UNITED STATES PATENT AND TRADEMARK OFFICE

| APPLICATION NO. | FILING DATE | FIRST NAMED INVENTOR | ATTORNEY DOCKET NO. | CONFIRMATION NO. |
|-----------------|-------------|----------------------|---------------------|------------------|
| 10/706,661 | 11/12/2003 | Timothy Allen | 81074236 | 7278 |

Office Action Summary

DETAILED ACTION***Drawings***

Figure 2A

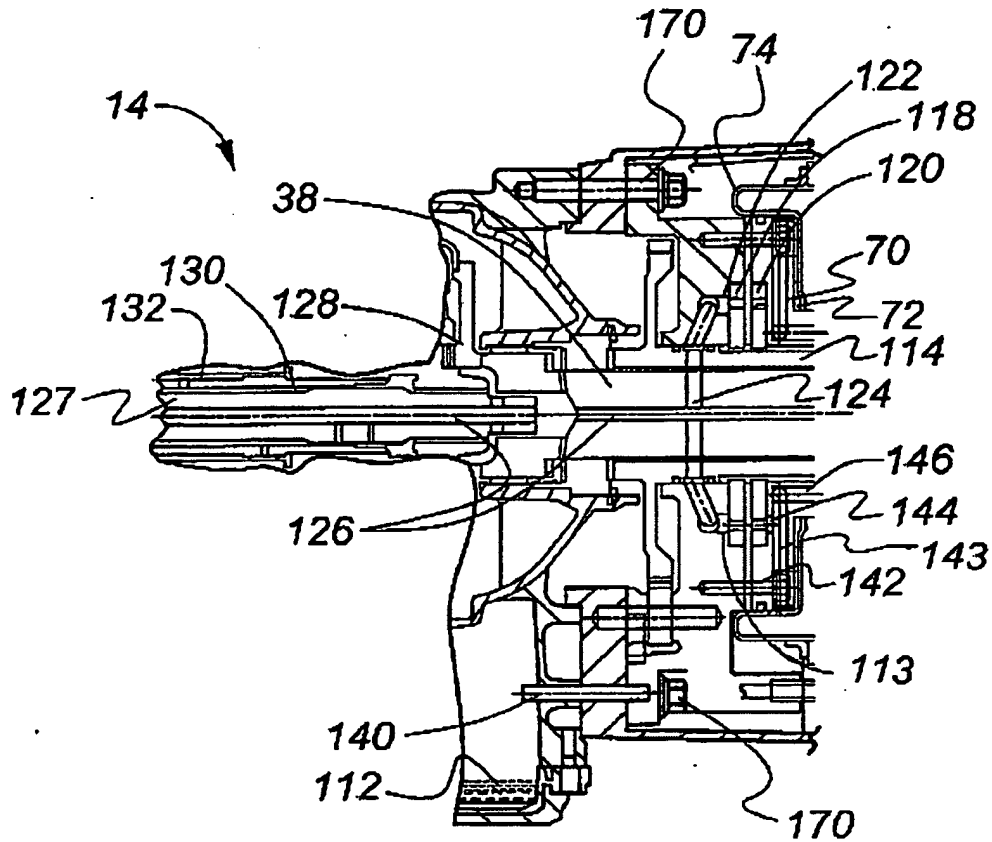
1. The drawings were received on Oct 31, 2006. These drawings are not approved for containing a new matter. The sump 110 having the inlet 113 as newly included in Figure 2A is considered a new matter since the Specification and the Drawings as originally filed fail to show or even suggest that the passage 113 is the inlet for the sump 110 as shown in Fig. 2B.

3. The amendment filed Oct 31, 2006 is objected to under 35 U.S.C. 132(a) because it introduces new matter into the disclosure. 35 U.S.C. 132(a) states that no amendment shall introduce new matter into the disclosure of the invention. The added material which is not supported by the original disclosure is as follows: the inlet of the pump 118 being hydraulically connected through passages 111 to **the inlet 113** of sump 110. (emphasis added)

8. Applicant's arguments filed Oct 31, 2006 have been fully considered but they are not persuasive. In regards to the amended Drawings, not to mention that the passages 111 is not in the Drawings, the inlet 113 of sump 110 appears to be a new matter. There is no description in the Specification or the Drawings, as originally filed, that the passage 113 as indicated in the amended Figure 2A is the inlet of the sump 110. Furthermore, the amendments to the Drawings and the Specification regarding the passages do not explain or meet the enablement requirements. As discussed above, the lubrication circuit between the scavenge pump 118 and the sump 110 is still confusing and unclear. Moreover, the lubrication circuit between the lube pump 120 and the sump 112, as amended, does not provide a clear picture of how the circuit is made. There is a missing fluid connection between the passages 140 and 142. It is not clear how the fluid in the sump 112 is pickup to be delivered to the passage 140. It is not clear how the circuit is completed, from the sump, to the pump, to the devices, and back to the original sump. Since, the amendment to the Drawings and the Specification fails to remedy the enablement requirement, the rejection under 35 USC 112, 1st paragraph remains.

not approved on 12/12/06

Applicant is required to cancel the new matter in the reply to this Office Action.

Figure 2B

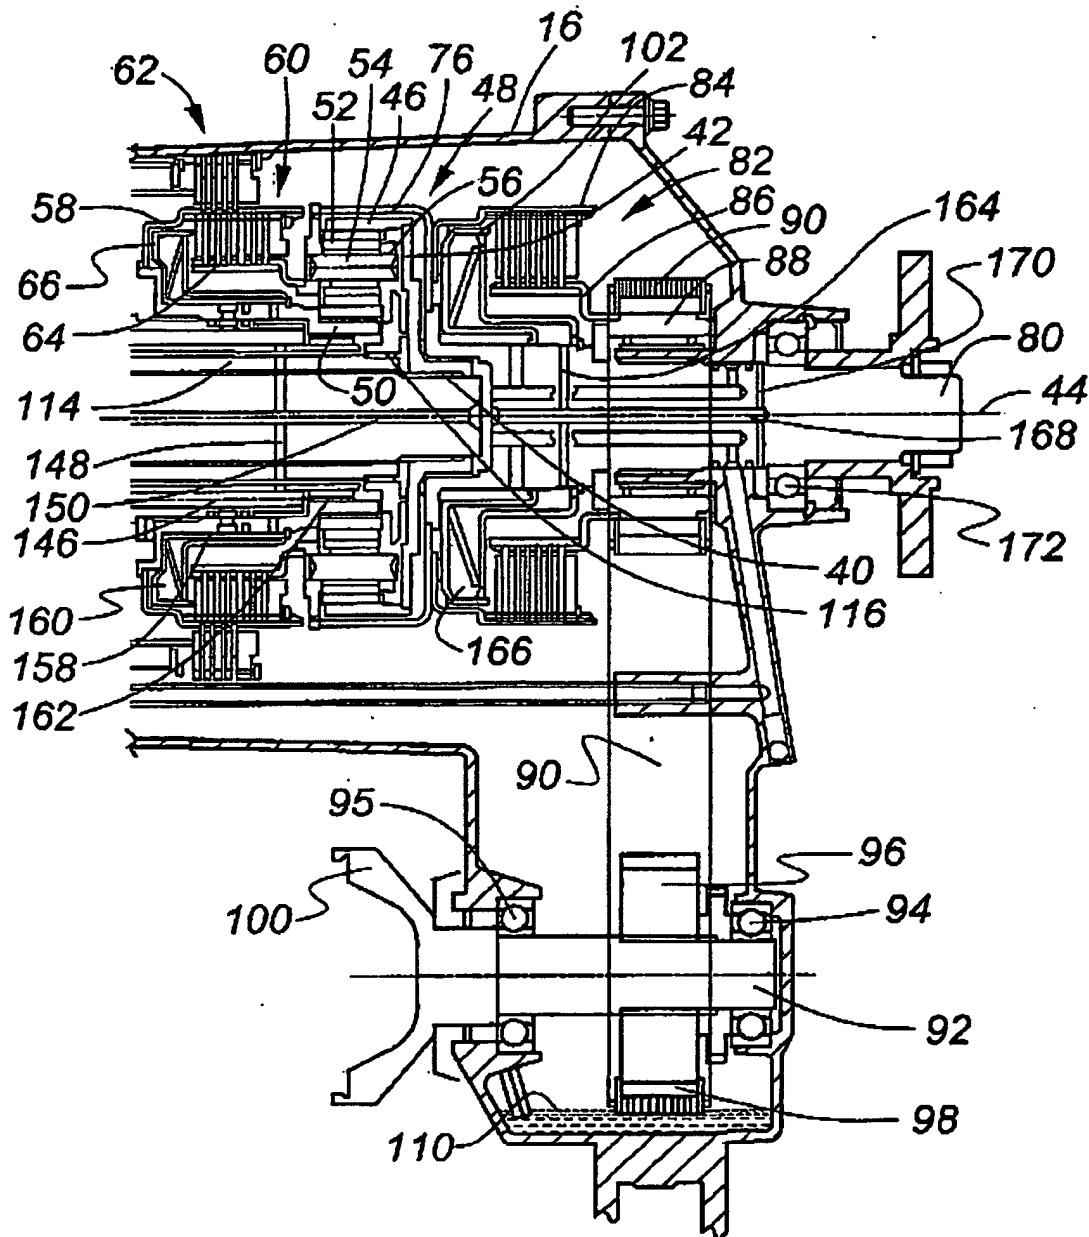
Not approved on 12/12/06
